MEETING SUMMARY

Throat Area/ Charles River Working Group, Allston Multimodal Project
July 30, 2024

Subject: New Option 5 Design Concept: Throat/River Edge, I-90 AMP

**New Conceptual Design:
Option 5: Retained Fill/
Sloped River Edge**

**New Conceptual Design:
Option 5: Retained Fill/
Sloped River Edge**

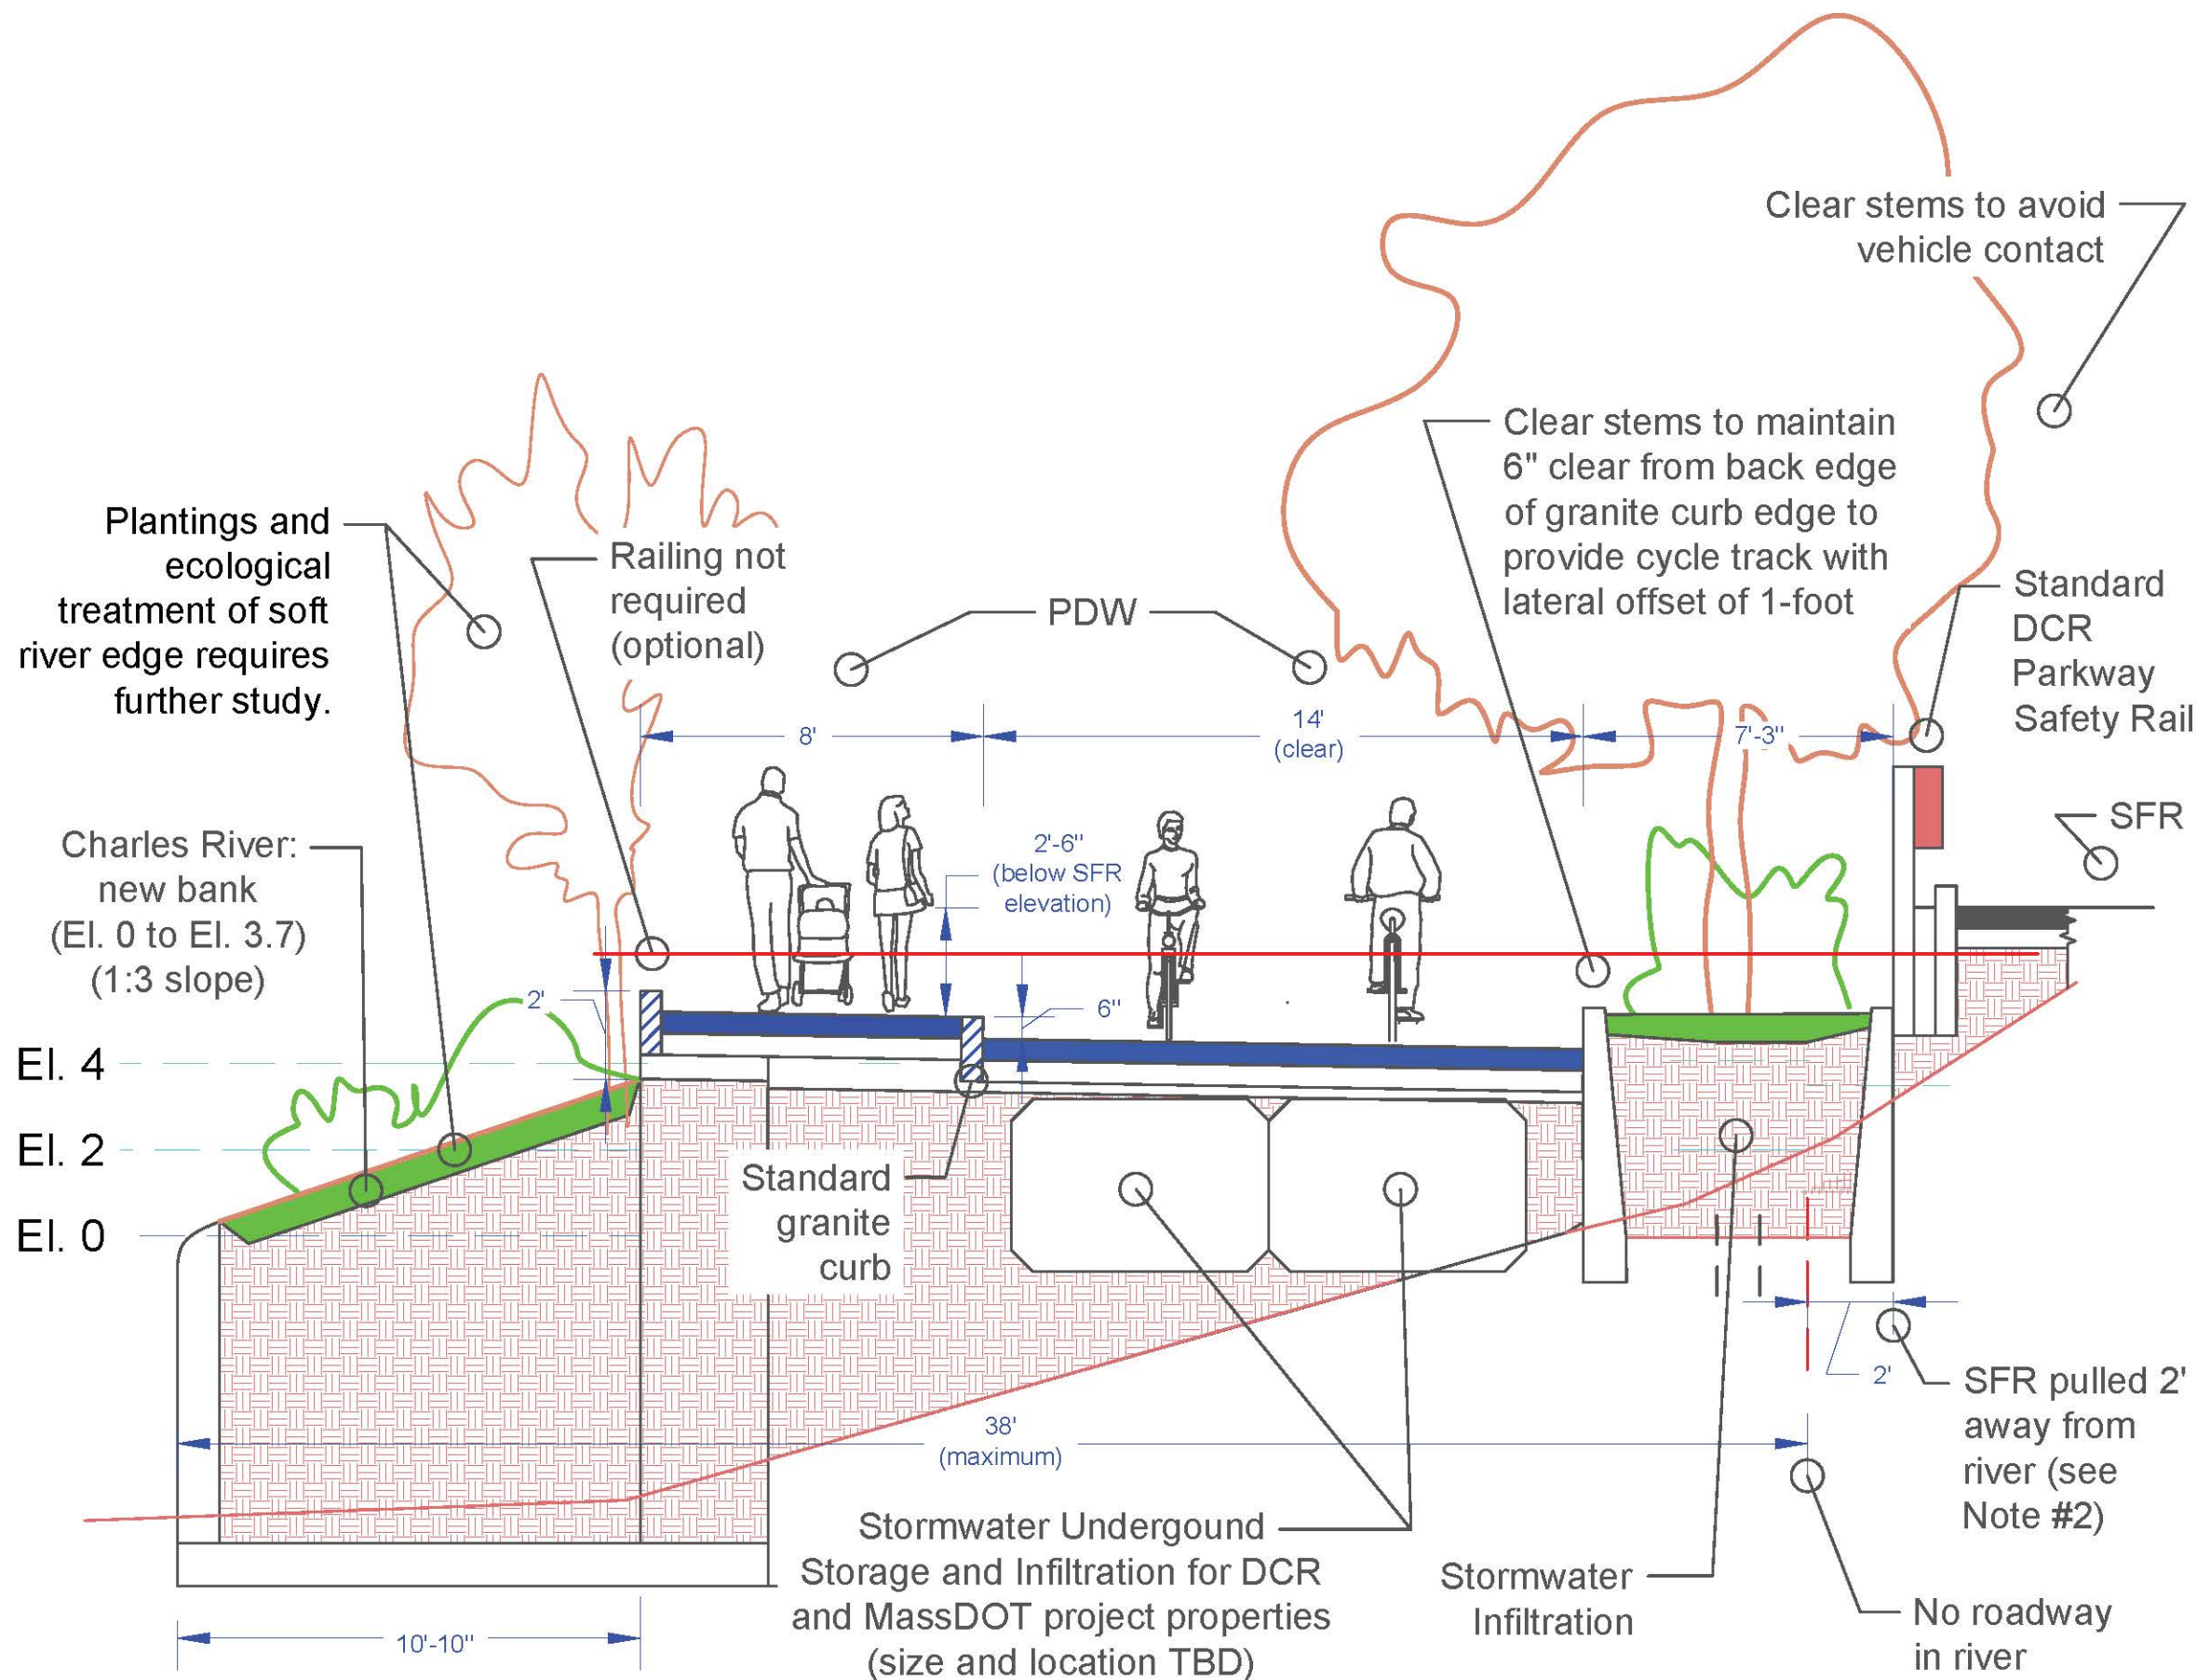
1. To provide the additional width of 2' needed to accommodate this Throat/River Edge design concept, SFR lanes shall be reduced from 10'-6" to 10'-0" (see DCR Historic Parkway Preservation Treatment Guidelines dated 2007).
2. Excerpt, MassDOT Separated Bike Lane Planning & Design Guide (2015), Section 3.3.2, Exhibit 3I: Bike Lane Widths for Two-way Operation, pp. 31.:

**New Conceptual Design:
Option 5: Retained Fill/
Sloped River Edge**

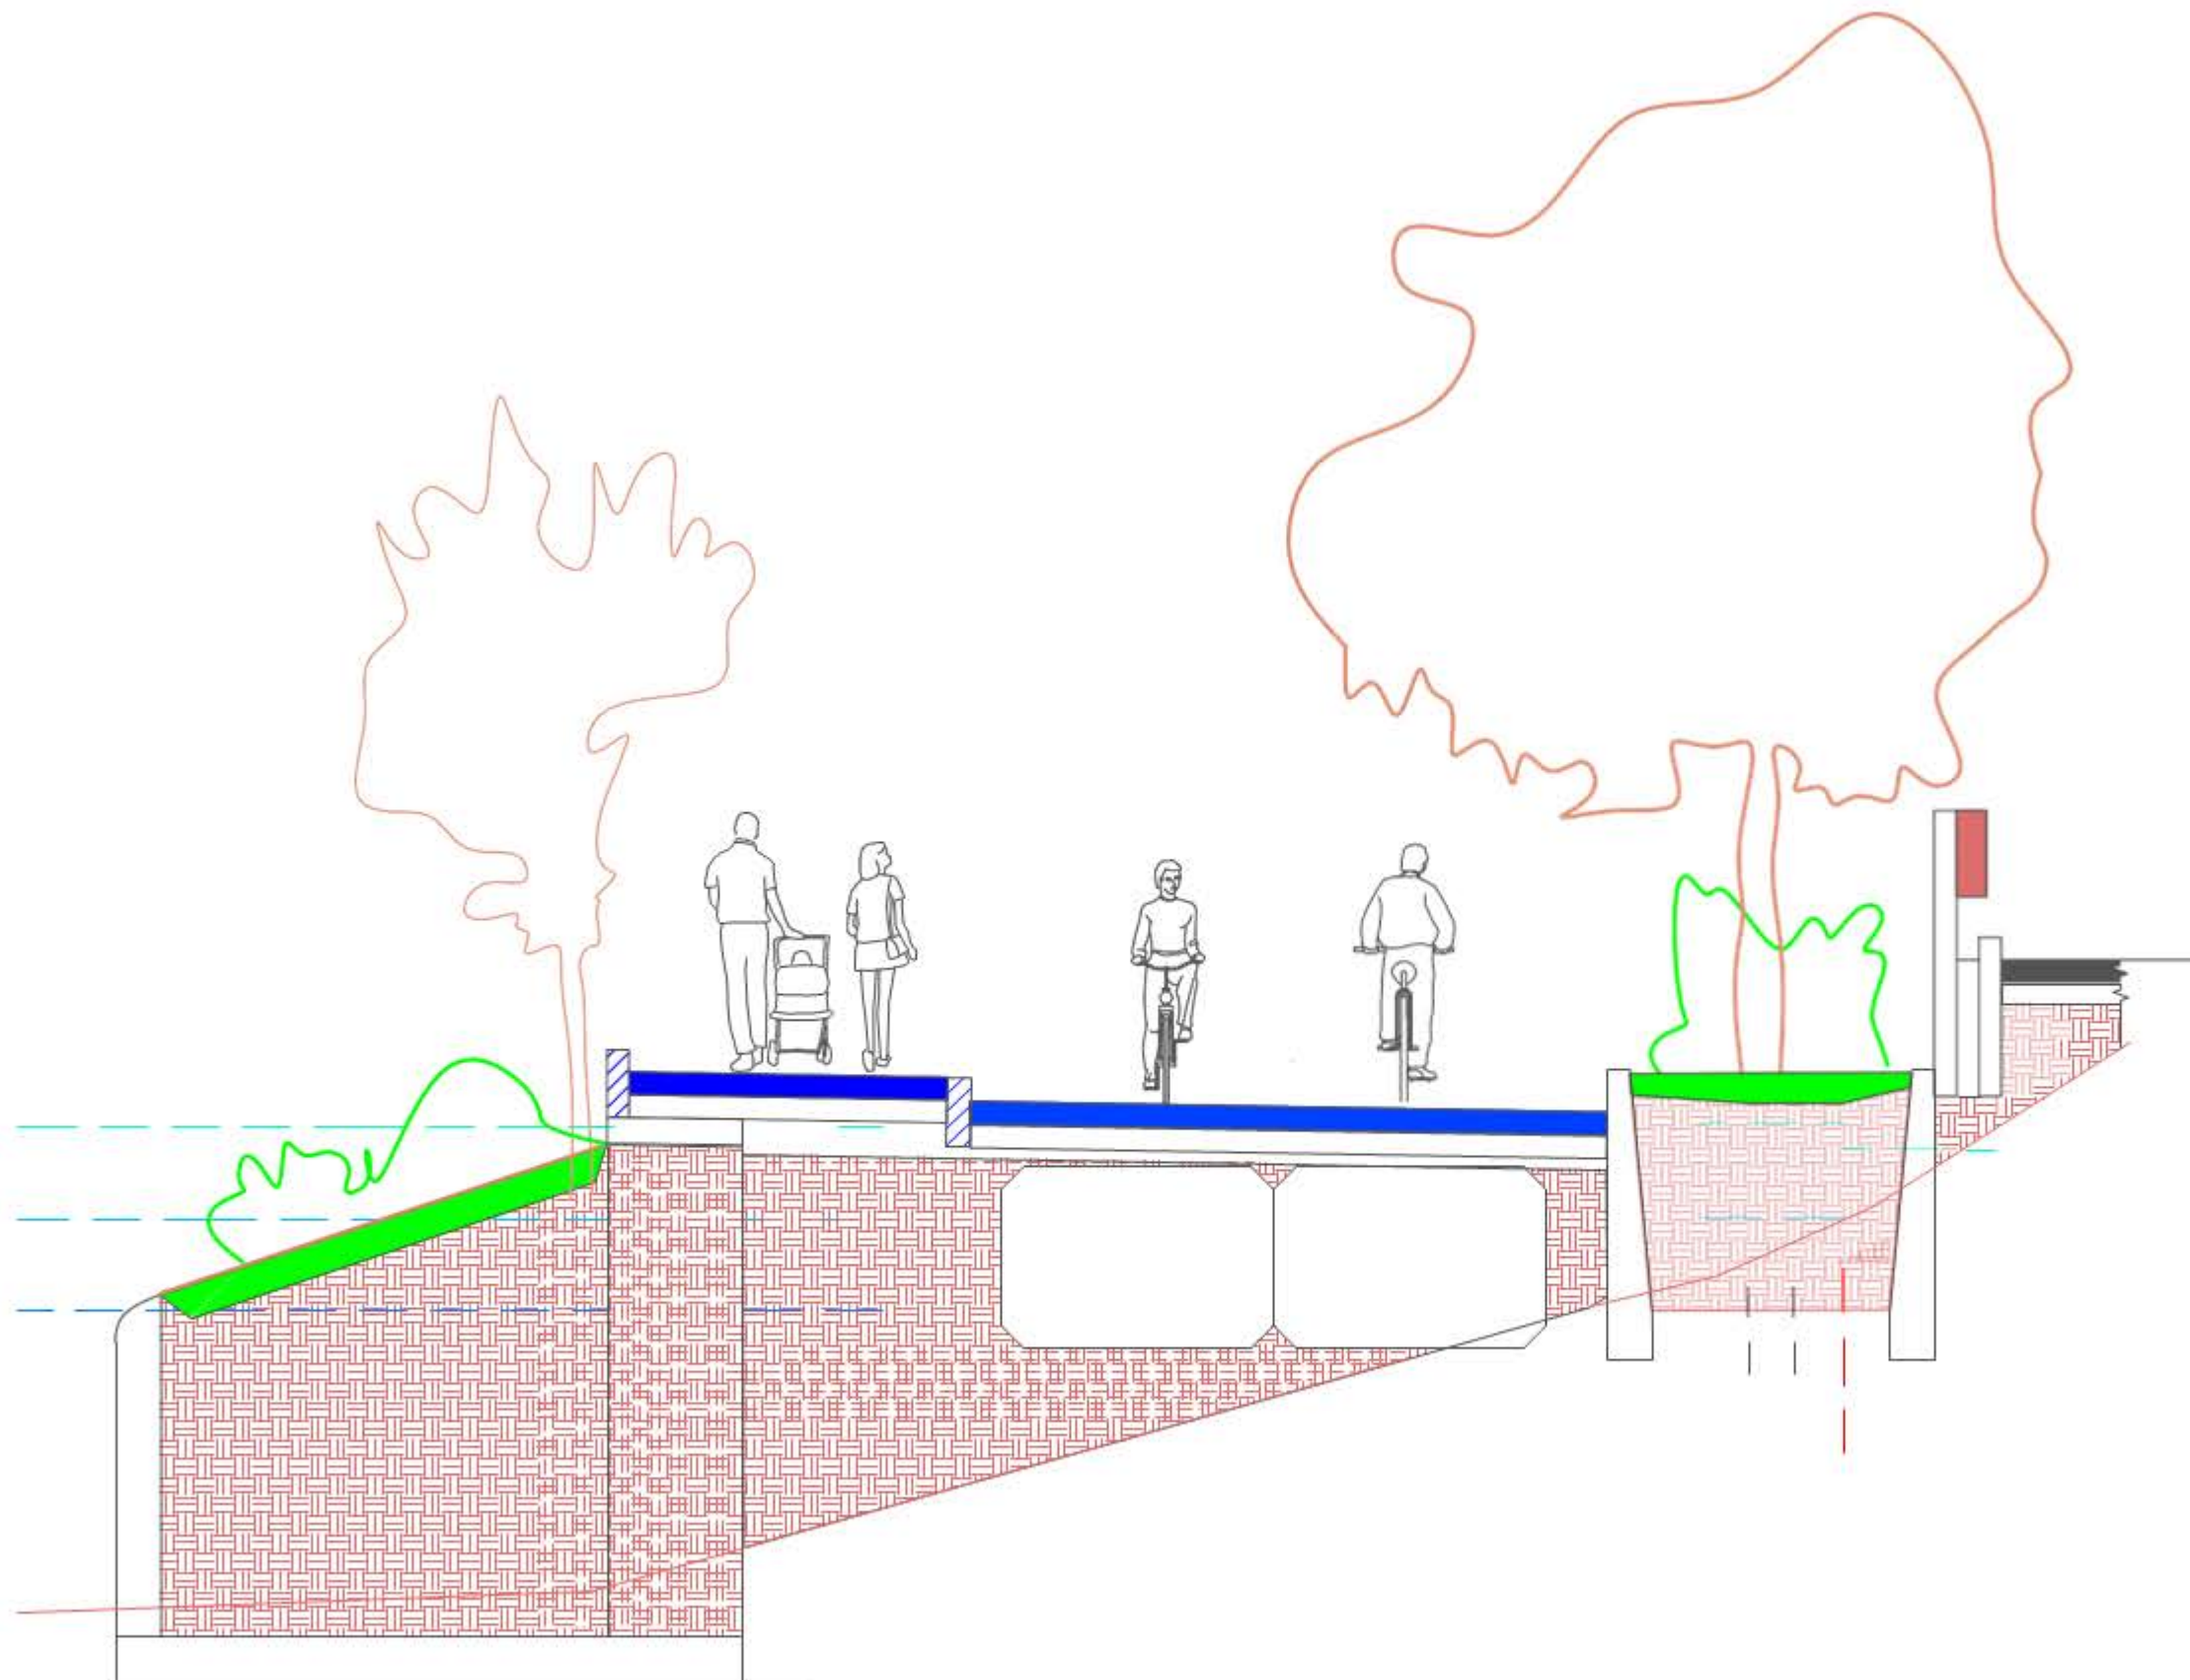
The Option 5 cross-section is 38-feet (maximum) in width at the narrowest part of the Throat, and thus satisfies MassDOT's objective to limit river fill to less than one-acre in accord with the New England District of the U.S. Army Corps of Engineers (USACE) General Permit regulations.

Working from the new river edge in, Option 5 contains a sloped natural river edge similar to what MassDOT showed the Working Group, except our edge runs between El. 0 and El. 3.75 (NAVD88 datum) and now transitions at its top without the need for a vertical wall. We believe starting the new river edge at El. 0 is extremely important both to minimize wave reflection and to allow river users needing to gain rapid and safe egress out of the water be able to do so. The attached updated plans show a safety railing is no longer required because the adjacent vertical drop is now less than 30". We revised this part of the design in response to two key comments made at this week's Working Group. First, we believe it satisfies the Charles River Alliance of Boaters request to see the new soft river edge slope begin at El. 0—not the higher El. 1.5 currently shown for Options "A" thru "C". Further, we believe the change to delete the railing helps address comments made by the Department of Conservation and Recreation and City of Boston that work crews be given ready access to maintain the new soft slope. This improved design also provides more space and plantings on the new river edge to be located above the height of typical water levels and adds 0.7 feet in width

With respect to pedestrian and bicycle accommodations, a single, shared multi-use pathway is not acceptable here. For that reason, we strongly recommend the separated pedestrian and bicycle paths depicted in Option 5. The pedestrian path is 8-feet wide, and grade separated from the cycle-track by a standard granite curb. The two-way cycle track is 14-feet wide in accordance with MassDOT design standards and in full support of city/state climate change and public health objectives.

Option 5 includes a landscape buffer between the new river park spaces and Soldiers Field Road (SFR) in the Throat. This important planting area is about 7.25-feet wide—more than sufficient to grow large shade trees. We are confident that the SFR and park space interface can be designed to minimize if not preclude any possible infrastructure damage from tree growth. To provide for the various widths as shown in Option 5, the plan calls for reducing the width of the lanes on SFR from 10.5-feet to 10.0-feet, in accordance with DCR Parkway Design Guidelines. Finally, Option 5 improves upon the At-Grade Option goal of having no roadway in the river by moving SFR two-feet further away from it. The co-signatories support the narrowing of SFR lane widths from 10.5-feet to at least 10-feet per DCR guidelines in order to allocate 2-feet of additional space to the new soft sloped river edge, separate pedestrian and bicycle paths, and buffer landscaped space. That said, please note that further discussion about the number and width of highway and parkway lanes may continue under separate cover as each co-signatory may wish to pursue.

1. Base taken from MassDOT Slide Deck Option 1 as presented to Task Force on June 10, 2024
2. See Sheet #2 for dimensions and additional notes.
3. Buffer trees between SFR and PDW shall be 5" caliper (min.) to maximize shade.
4. Pedestrian railing is not required nor shown. Pedestrian safety and egress for maintenance of river edge in Throat requires further study.
5. Barrier height between SFR and I-90 shall be raised to reduce highway noise impacts on Paul Dudley White pathways and river edge.
6. The cross-section needed to accommodate the Agganis Promenade requires further study.
